Technical Service Bulletin

01 MIL on (DTC P0300, P130A, and/or P0301 through P0304)

01 13 08 2033561/2 June 21, 2013. Supersedes Technical Service Bulletin Group 01 number 13-95 dated May 13, 2013 for reasons listed below.

Figure 3. A) part number, B) Bosch symbol.

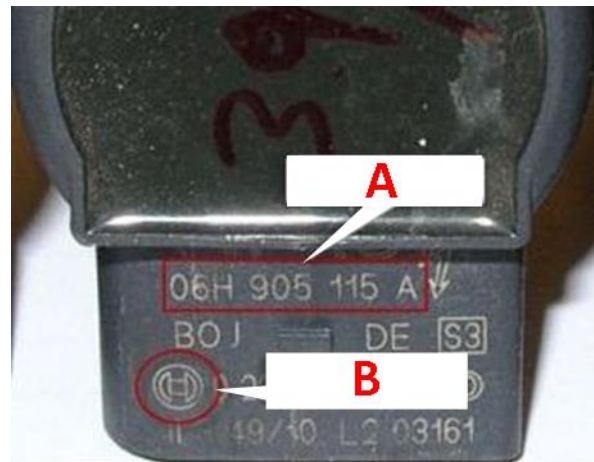
3. Check the part number of the coils (Figure 3). If one of the following part numbers is installed, all four ignition coils will need to be replaced:

- 06H 905 115
- 06H 905 115 A
- 06H 905 115 B

4. Replace all four ignition coils with part number **07K905715F** (ELDOR).
